Questions and Answers from Contractors

100% PROJECT PLANS

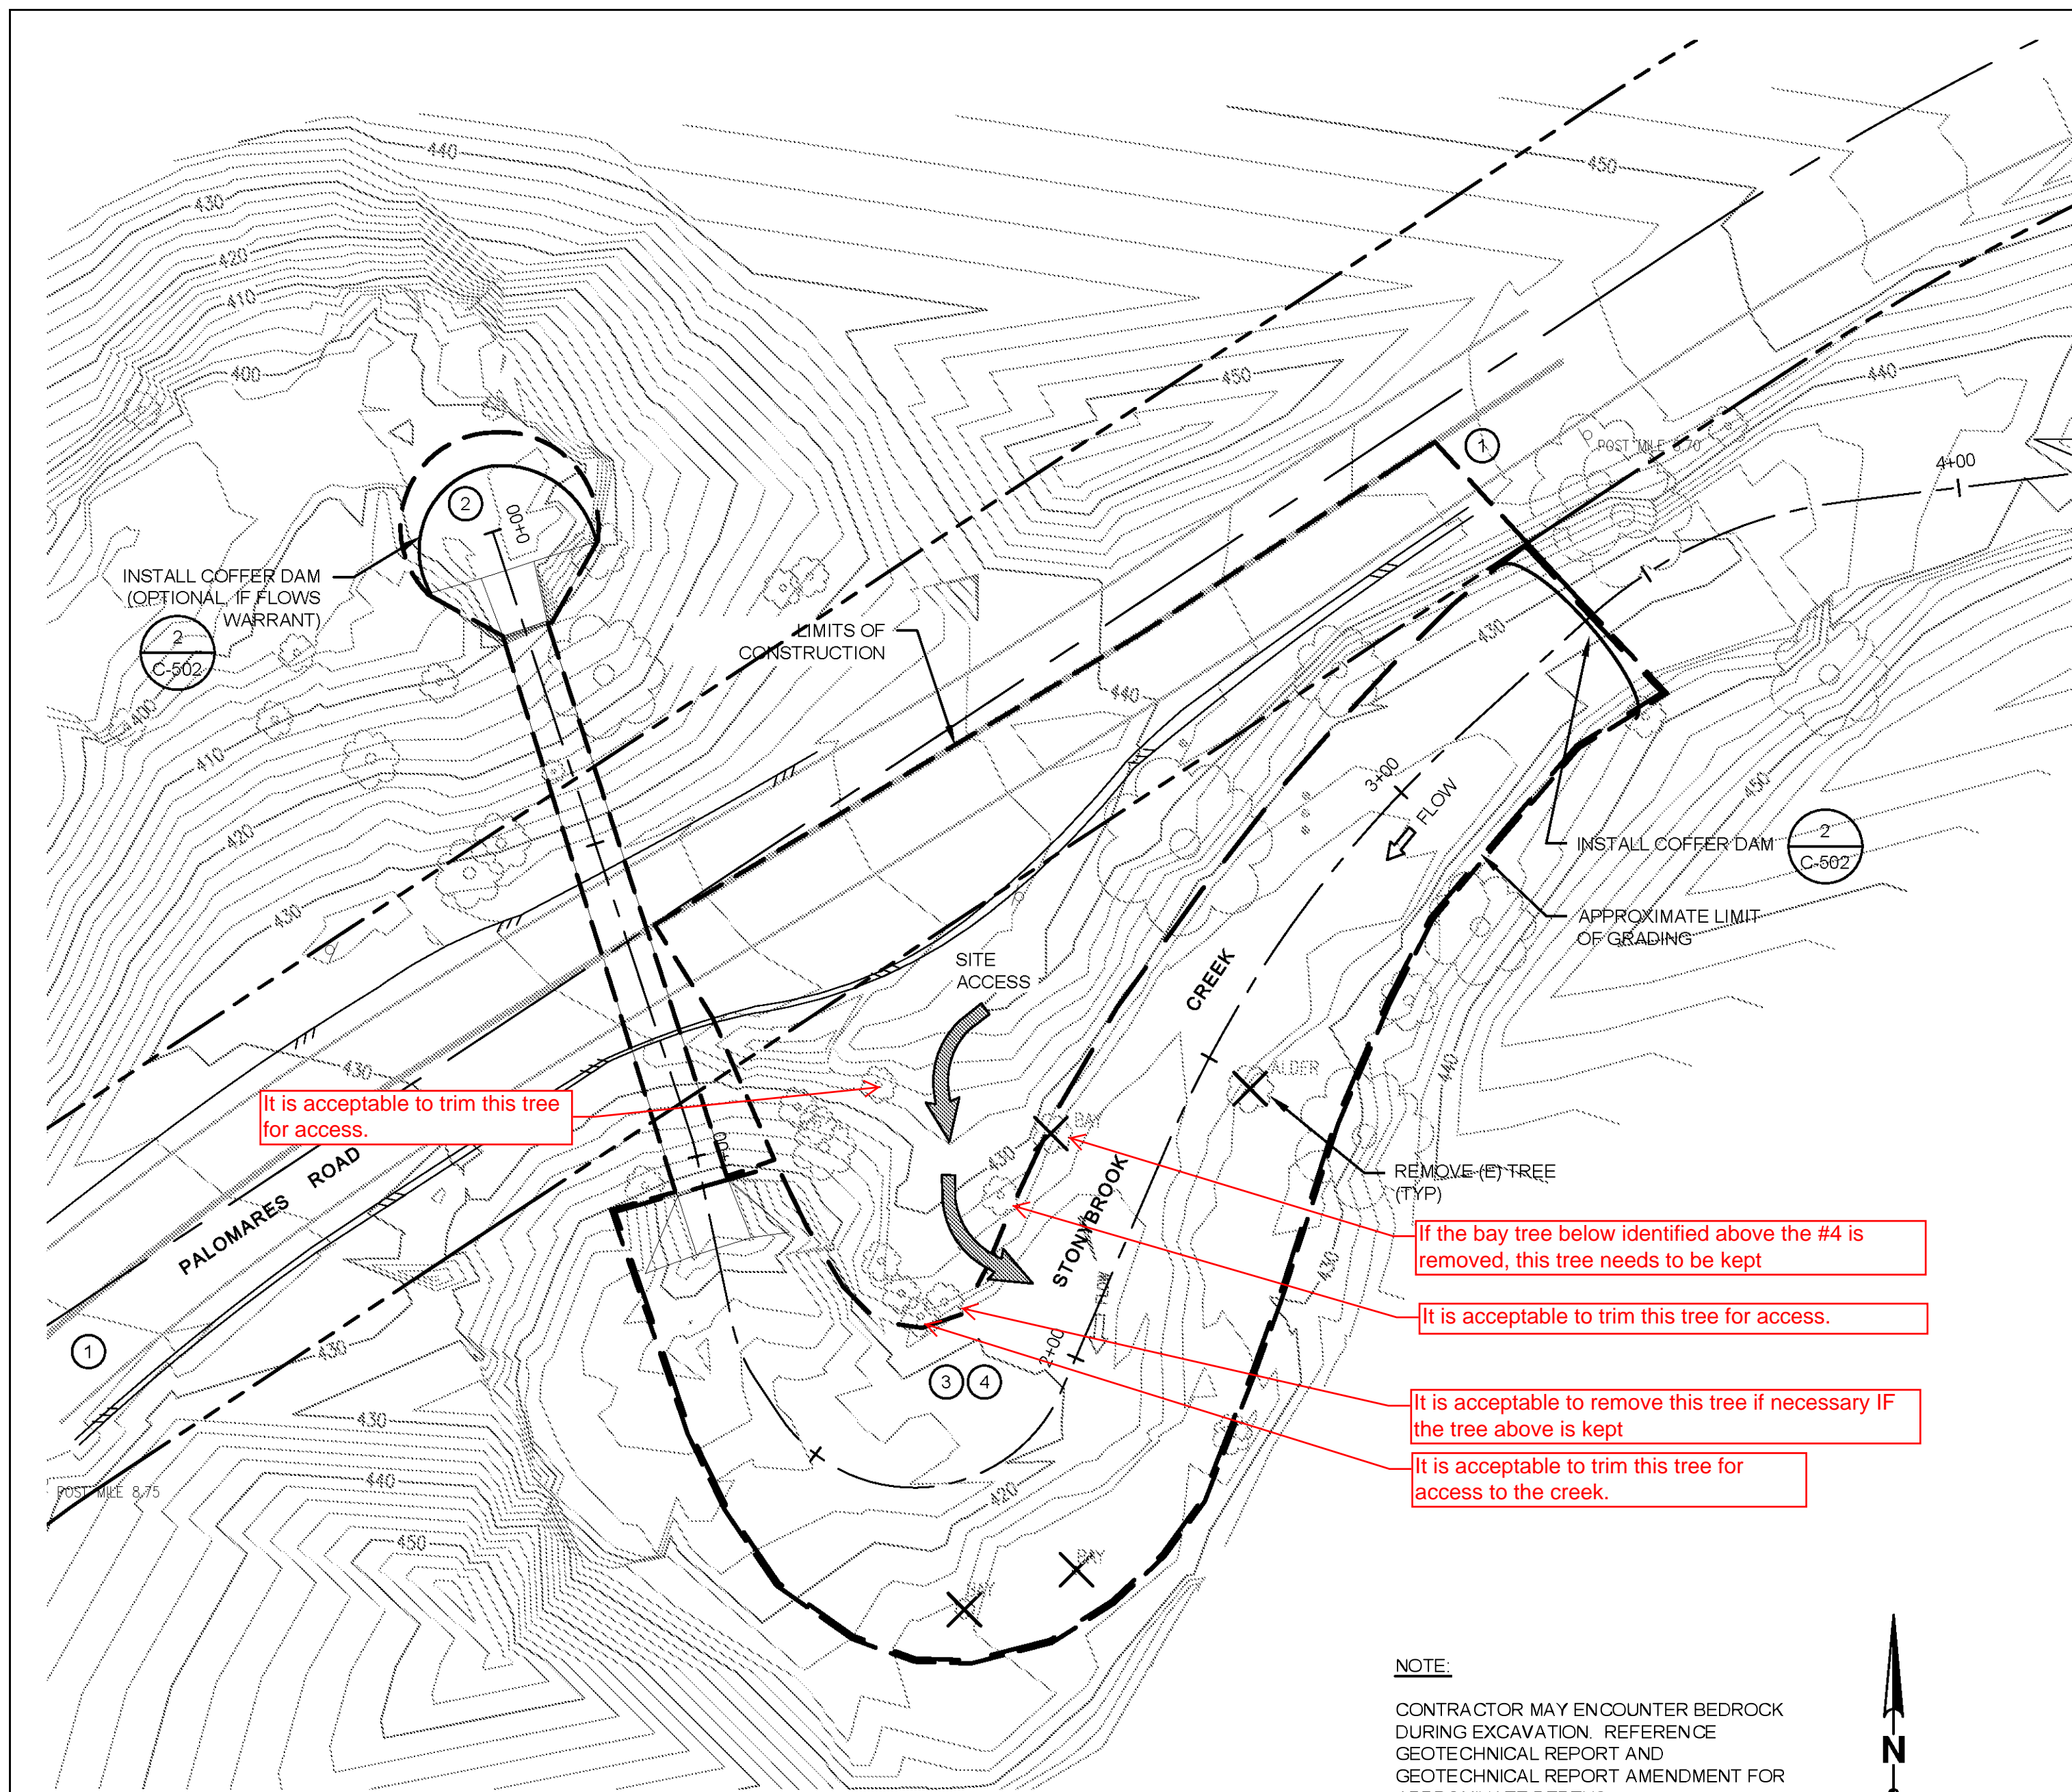
Q: Detail 3/C106 (Sheet C108) shows the abutment supported as a spread footing on unconsolidated material, whereas Detail 1/C107 (Sheet S501) shows the abutment dowelled into bedrock. Which scenario should we anticipate and include in the bid?

A: The abutment will be doweled into bedrock.

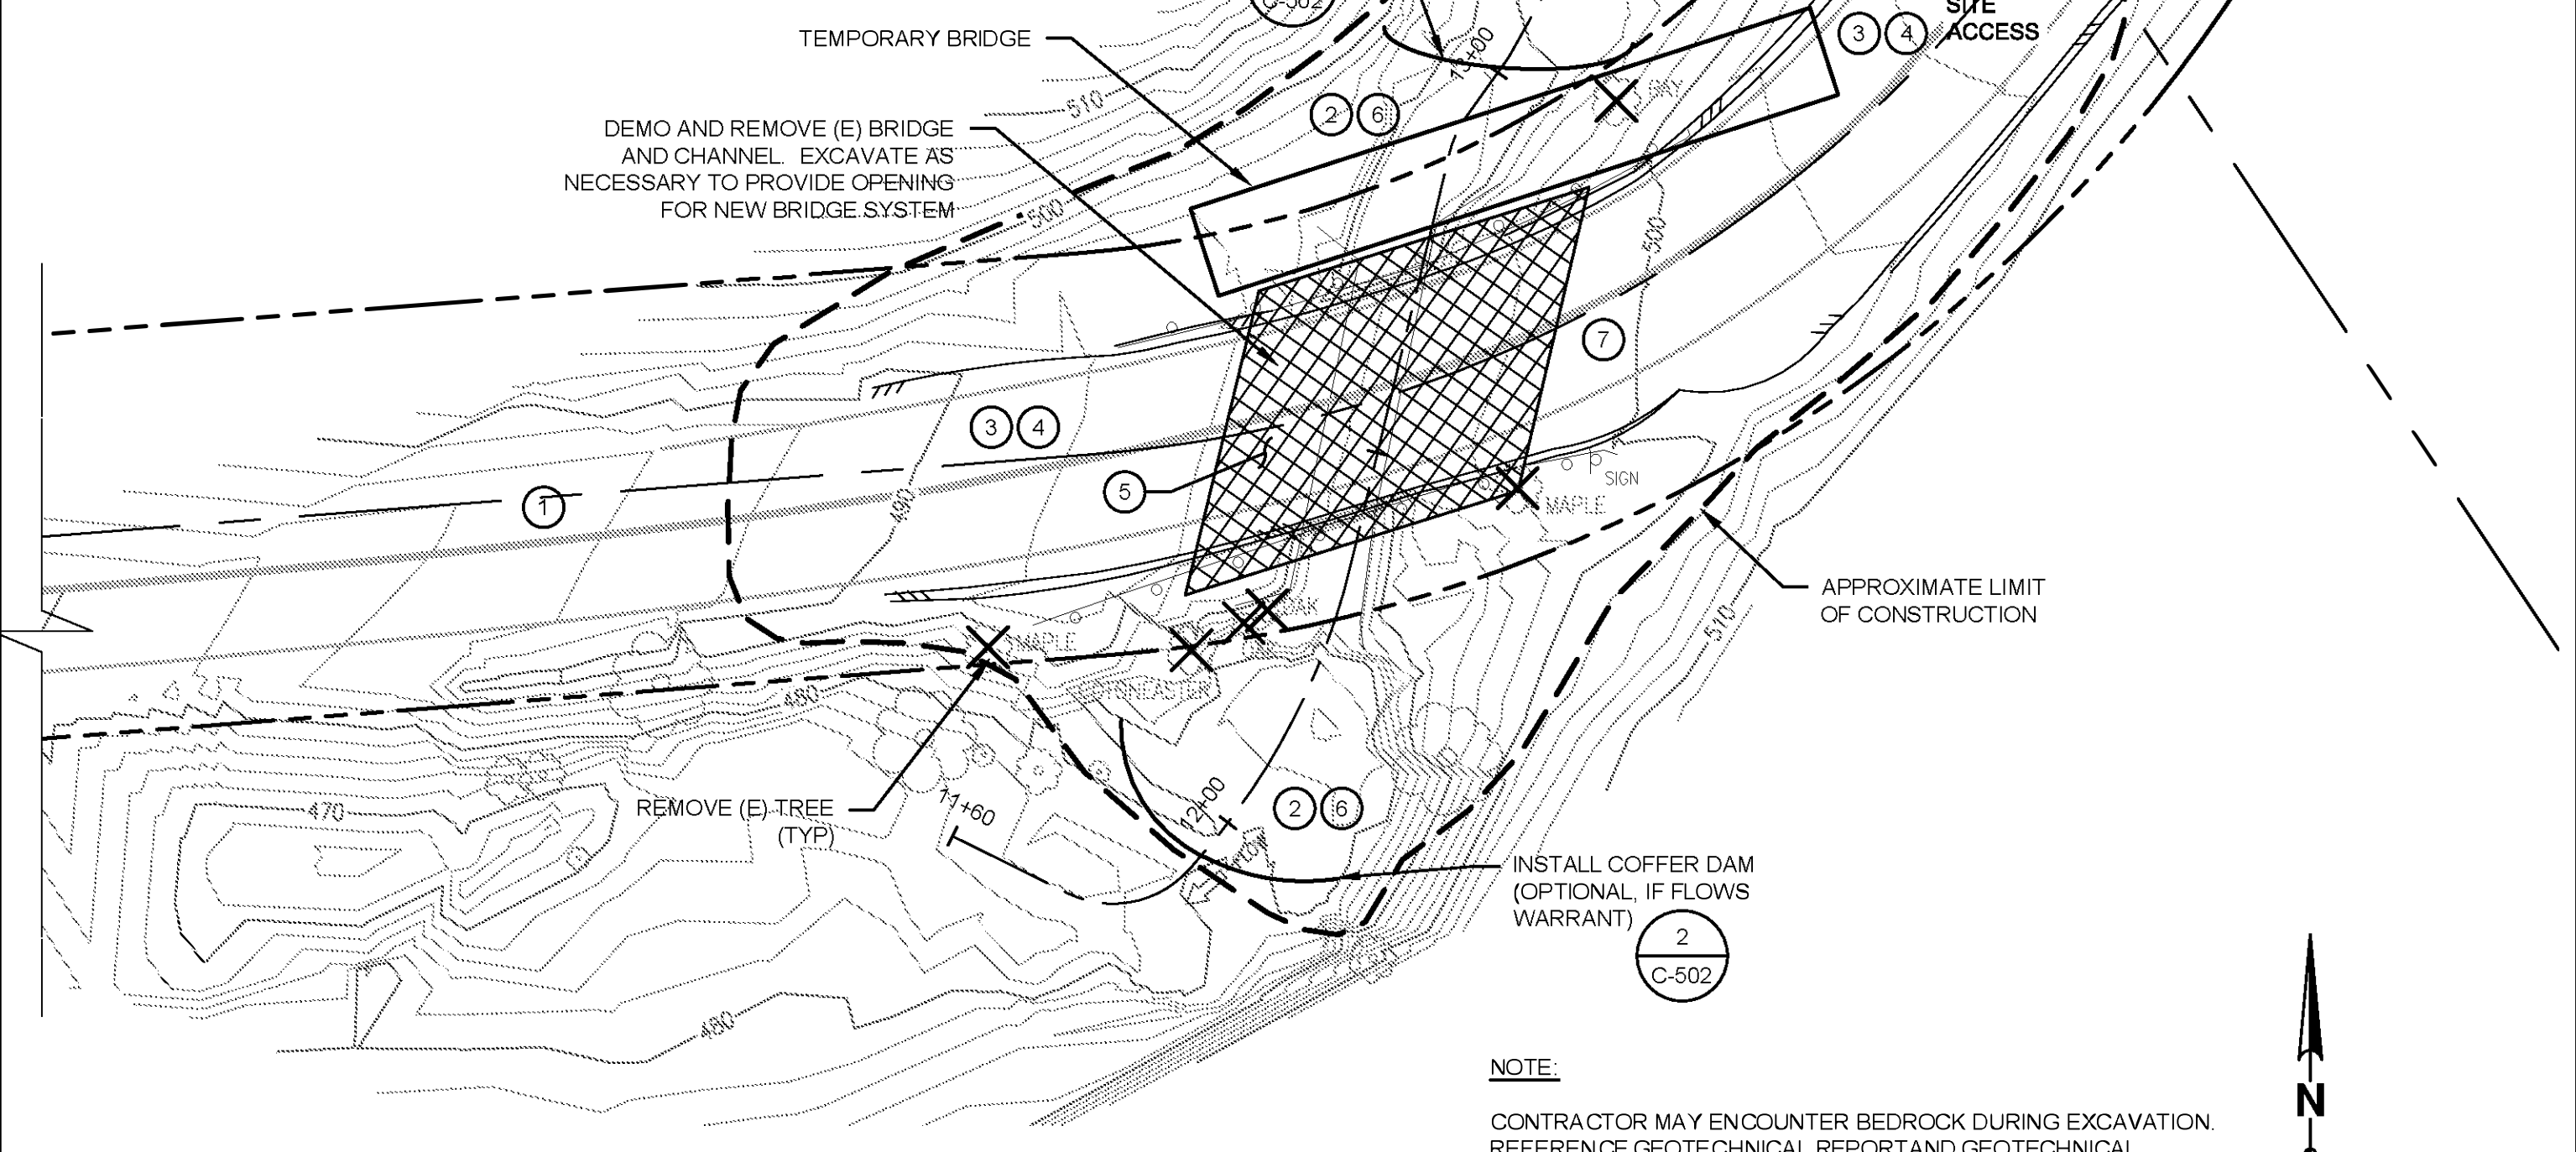
Q: For safe access to the lower reach, may the contractor remove the cluster of bays immediately above the #4 shown on Sheet C101 and the tree that is in line with #4 and the bay cluster near the road? May the contractor remove branches from trees other than those marked for removal? To facilitate access, may the contractor remove the mound of dirt at the roadside?

A: The trees identified on the revised Sheet C101 may be removed or trimmed. If additional trimming or removal is considered is necessary it must be approved by the Engineer.

Contractor may remove dirt mound for construction access and replace/compact at completion of PM 8.75 work.
